Subject: Submittal Supporting Accelerated ABWR Review Schedule - **Sample Pipe
Break Analysis Report and Appendix 3L Modification (Replacement)**

Enclosed are replacements to SSAR markups of new Appendix 3L and to the report
GE-NE-123-E070-0493 "Sample Analysis for the Effect of Postulated Pipe Break ABWR Main
Steam Piping" provided in my May 18, 1993 letter.

**SAMPLE ANALYSIS FOR THE
EFFECT OF POSTULATED PIPE BREAK
ABWR MAIN STEAM PIPING**

SIMPLIFIED PIPING MODELS

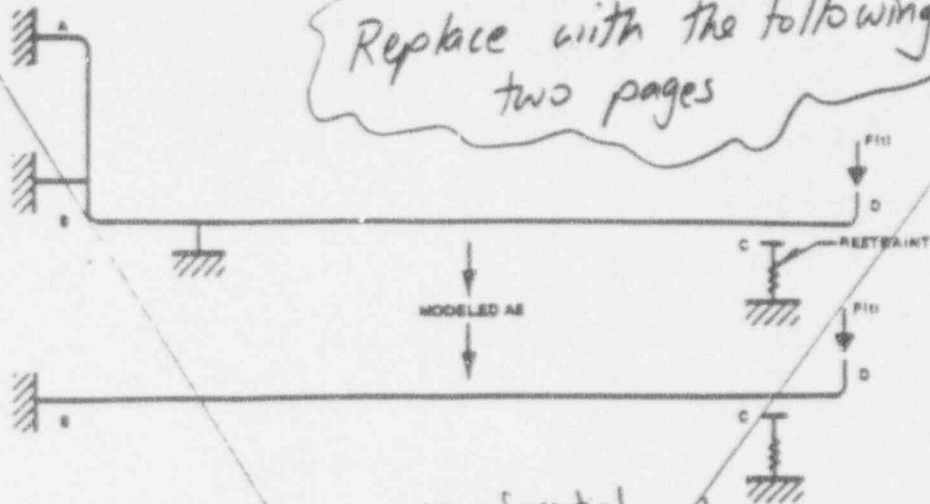
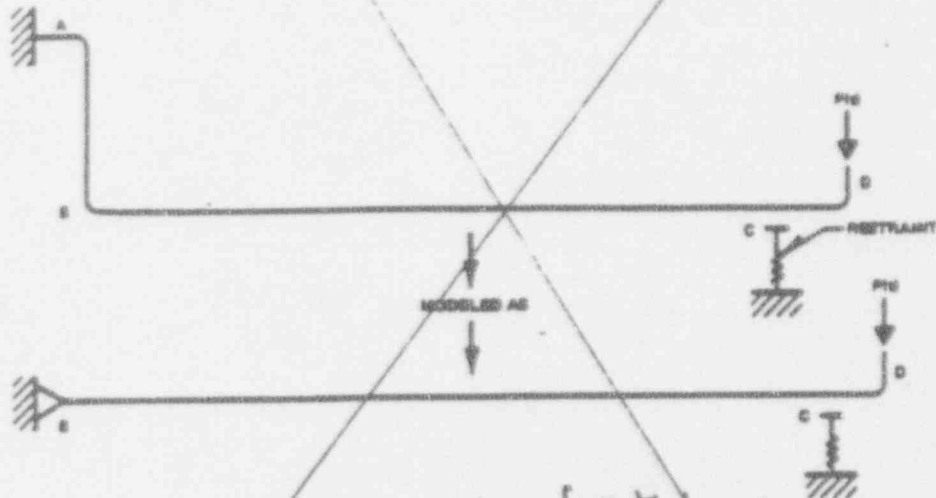
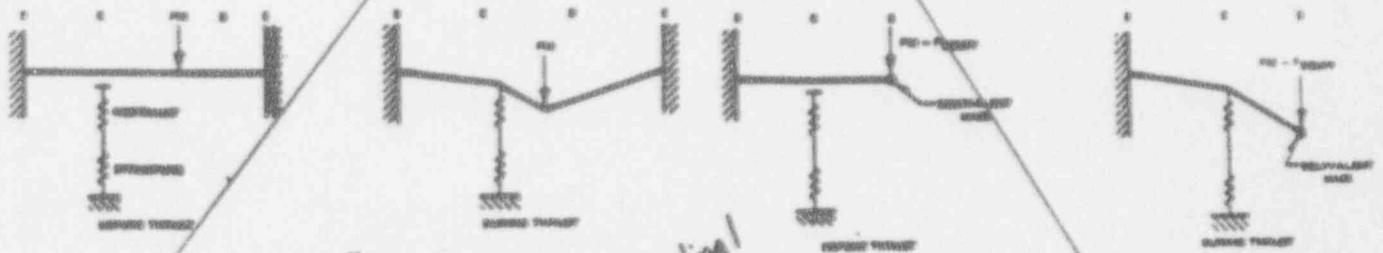
Replace with the following two pages

circumferential rupture using
Figure 6-2. Representation of Built-in Pipe

circumferential rupture using
Figure 6-3. Representation of Flanged-Pipe

longitudinal rupture
Figure 6-4. Representation of Pipe With Both Ends Built In

Simplified Piping Models

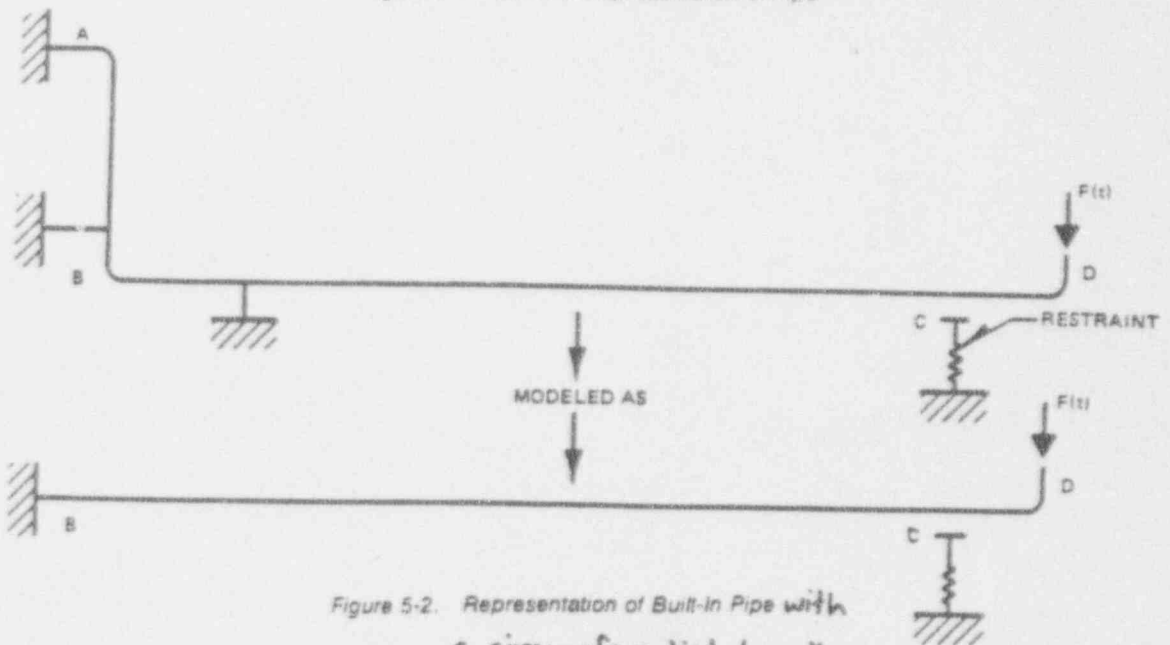
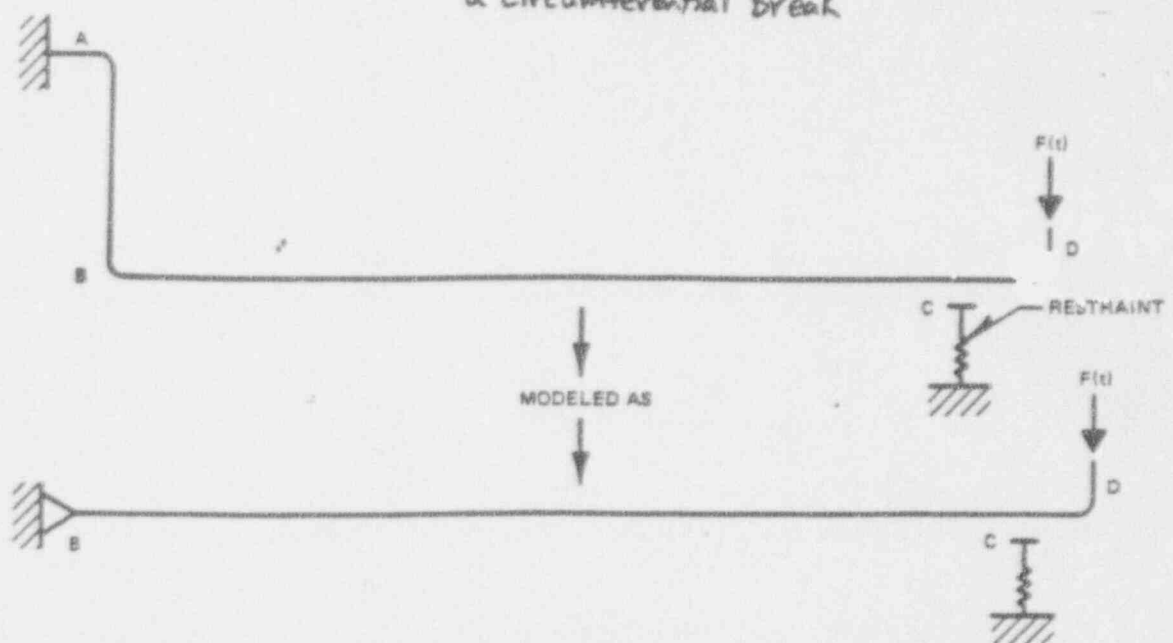
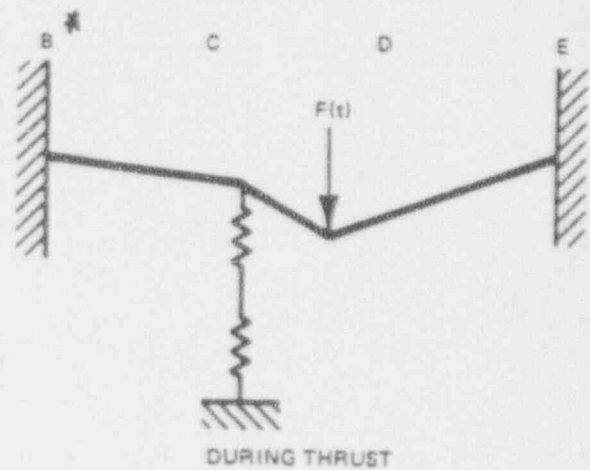
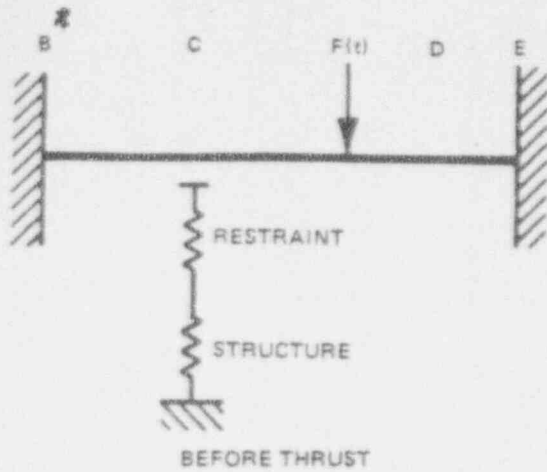
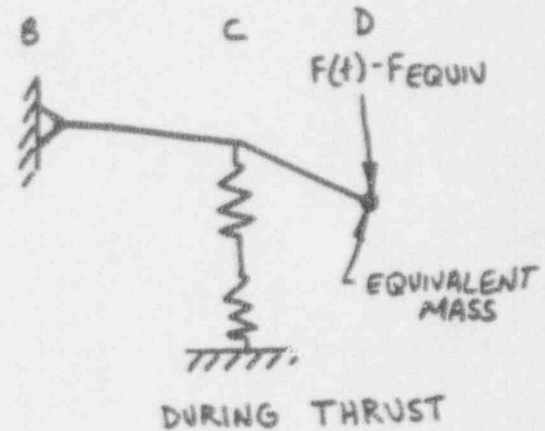
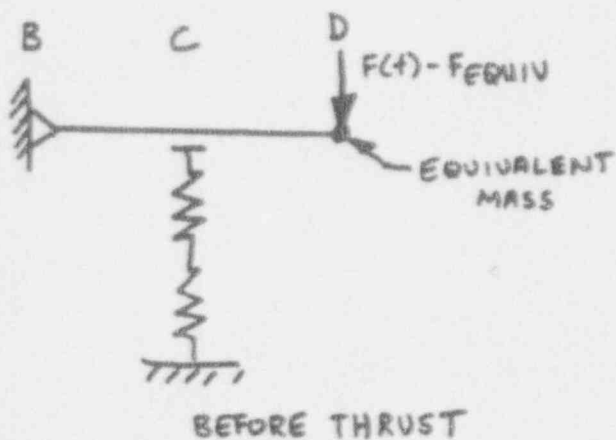
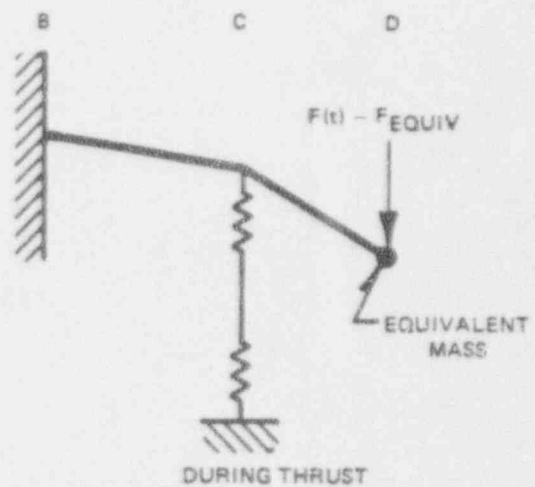
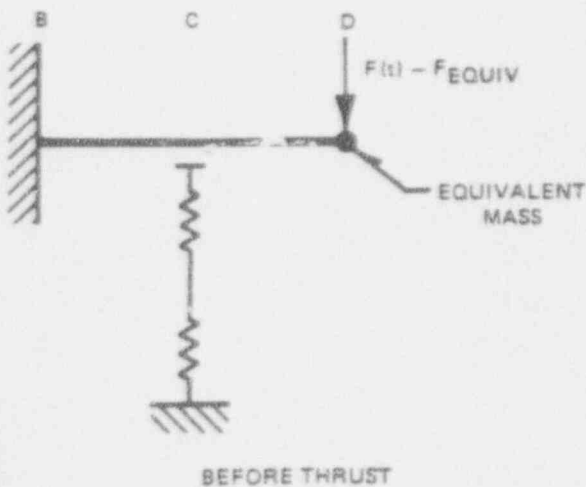
INSERT 3L.4.2.1 a

For many piping systems, all required information on their response to a postulated pipe rupture can be determined by modeling a portion of the piping system as a cantilever with either a fixed or pinned end. The fixed end model, as shown in Figure 5-2, is used for piping systems where the stiffness of the piping segment located between A and B is such that the slope of the pipe length, BD, at B, will be approximately zero. The pinned end model, as shown in Figure 5-3, is used for piping systems where the slope of the pipe length, BD, at B, is much greater than zero. The pinned end model is also used whenever it is not clear that the pipe end is fixed.

A simplified cantilever model may also be used for a postulated longitudinal break in a pipe supported at both ends, as shown in Figure 5-4. The pipe can have both ends fixed or have a pinned end at B and a fixed end at E, as shown in Figure 5-4. Section 3L.4.1(i) discusses the simplification techniques used to allow the use of a cantilever model. A fixed end is used when the rotational stiffness of the piping at that location is such that the slope of the pipe at that end is approximately zero. A pinned end is used when the pipe slope at that end is much greater than zero. If it is not clear whether an end is fixed or pinned, the end condition giving more conservative results should be assumed.
